DATE: March 5, 2026

ADDENDUM NO. 3

PROJECT NO. DGS C-0576-0012 PHASE 001
PROJECT TITLE - SCI Chester - Electrical Upgrades

H.F. Lenz Co.
1407 Scalp Avenue
Johnstown, Pennsylvania, 15904

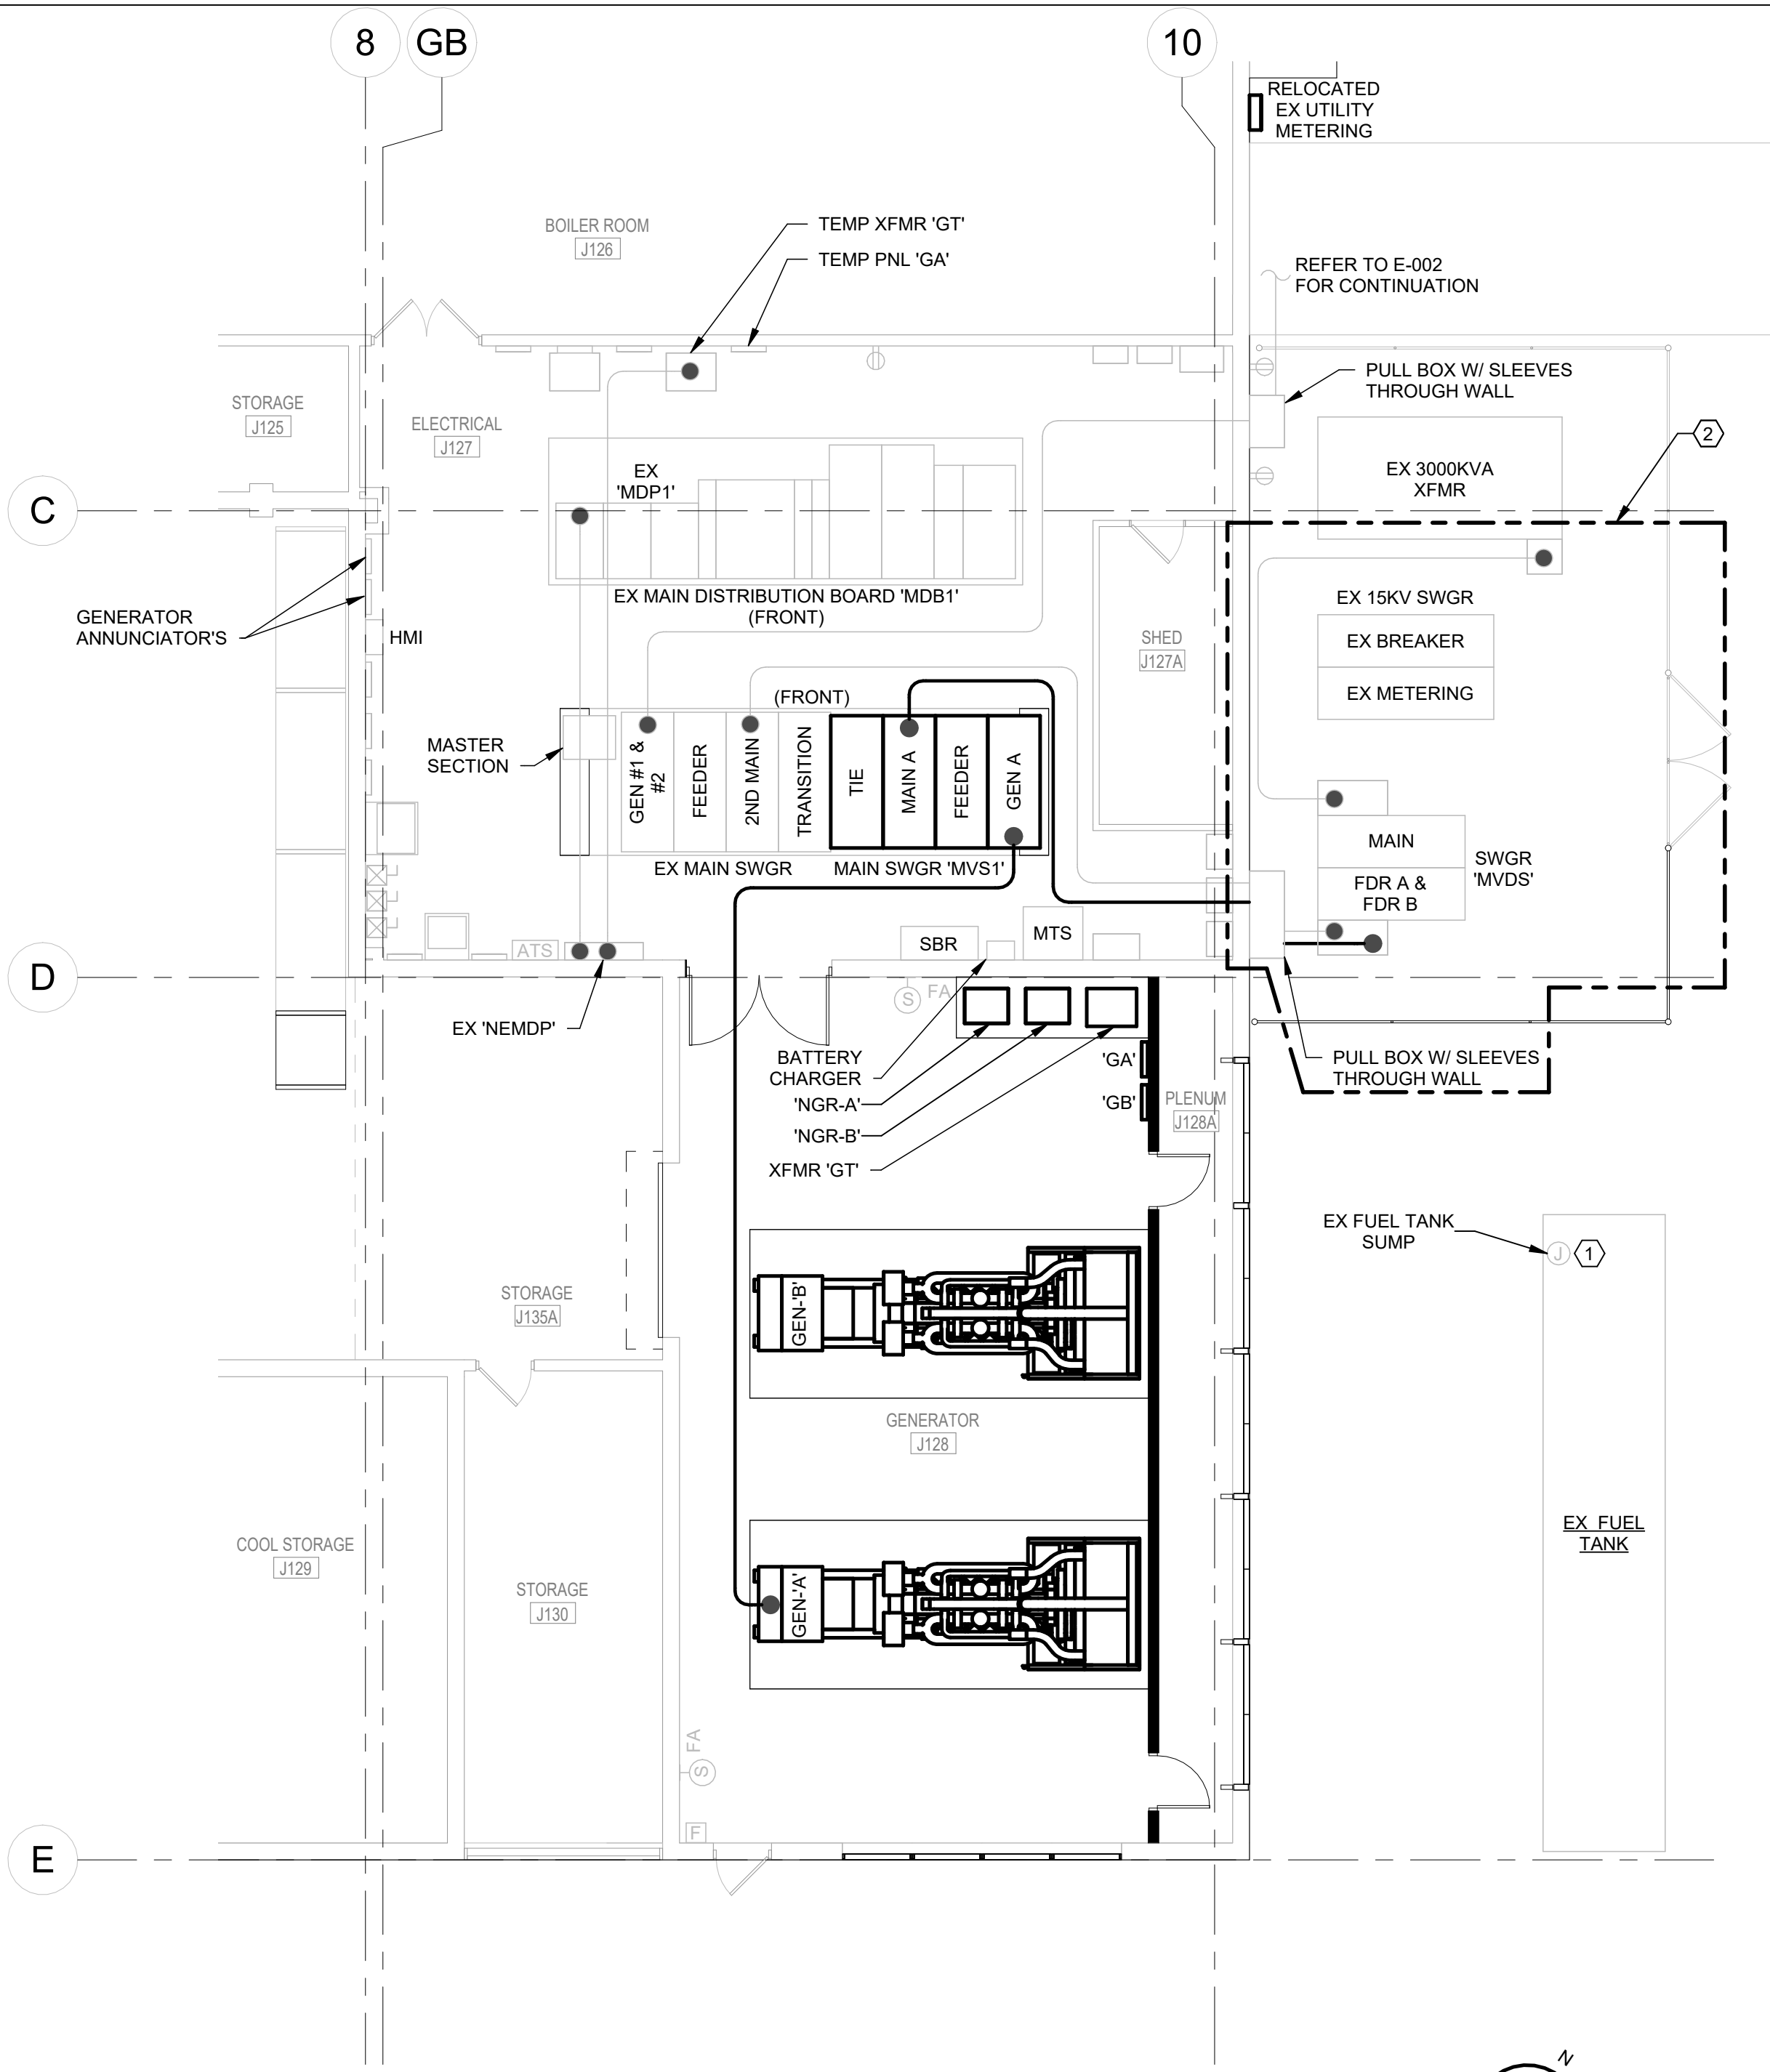
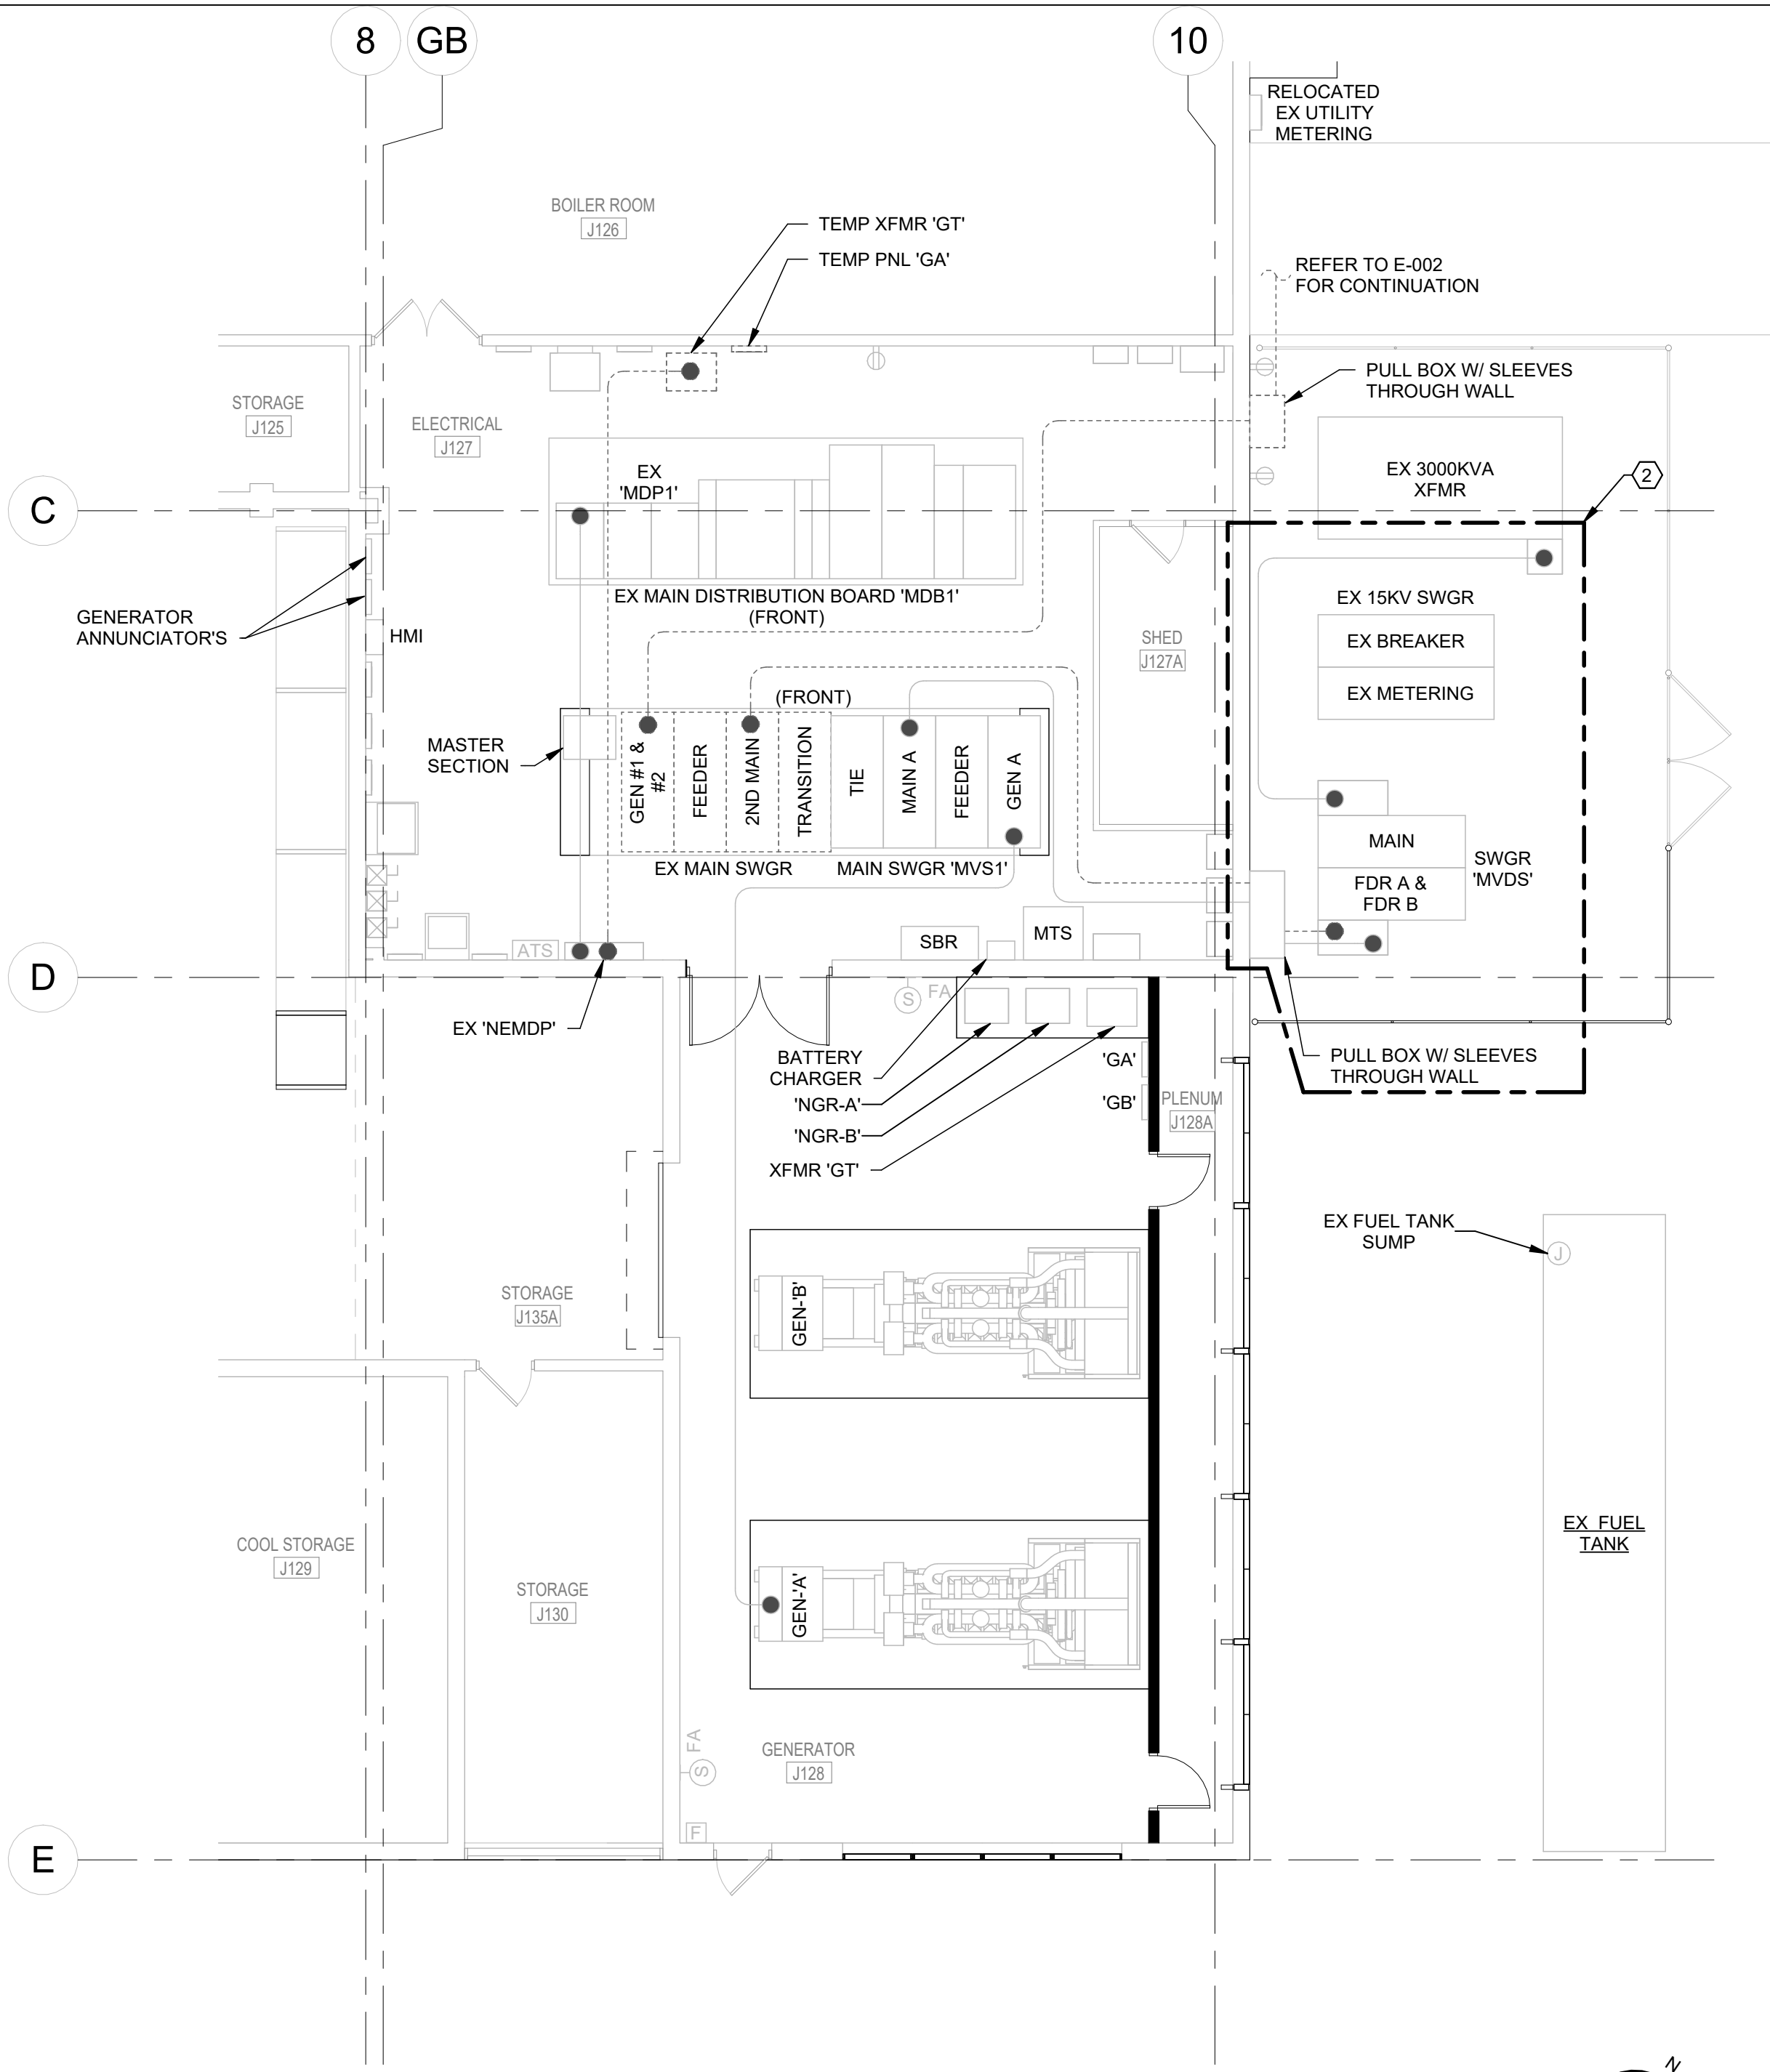
1. Drawings E-101, E-102, E-103, E-104, E-105, E-501, E-502, E-503: Voltage feeding 'EX 15KV SWGR' revised to read: "EX UTILITY FROM PECO 13.2/7.62KV"
2. Drawing E-102: Reference markers on 1/E-102 revised to reference drawing E-102.
3. Drawing E-301:

13. Question: Single line shows 480/277 volts feeding the ex 15KV SWGR main service feed is this a typo?

Response: Drawings revised to indicate service voltage of 13.2/7.62kV.
